Detailed Response to Reviewers

Ms. Ref. No.: ESWA-D-21-06199 Title: Formation Control for UAVs Using a Flux Guided Approach Expert Systems With Applications

Title: Formation Control for UAVs Using a Flux Guided Approach

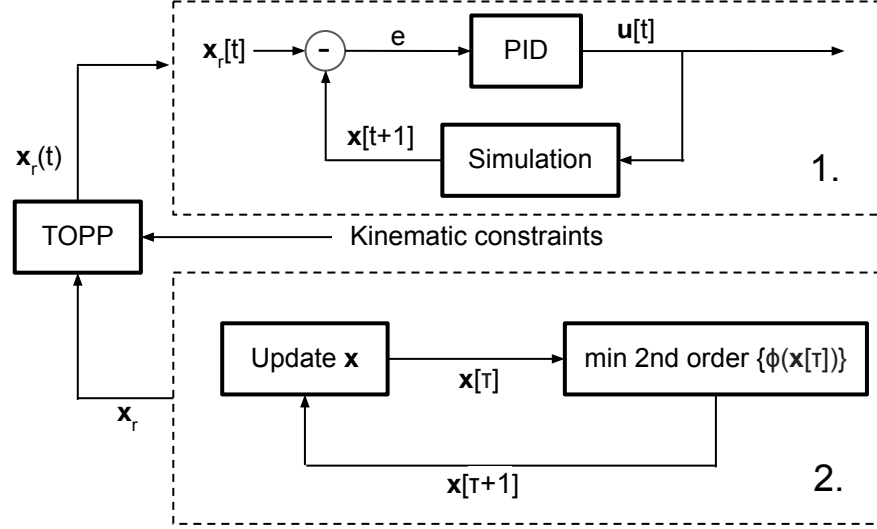
Reviewer #4: Provide an overall flowchart for the proposed methodology.

A new figure is added to illustrate the overall flow of the proposed methodology. Please see Figure 2.
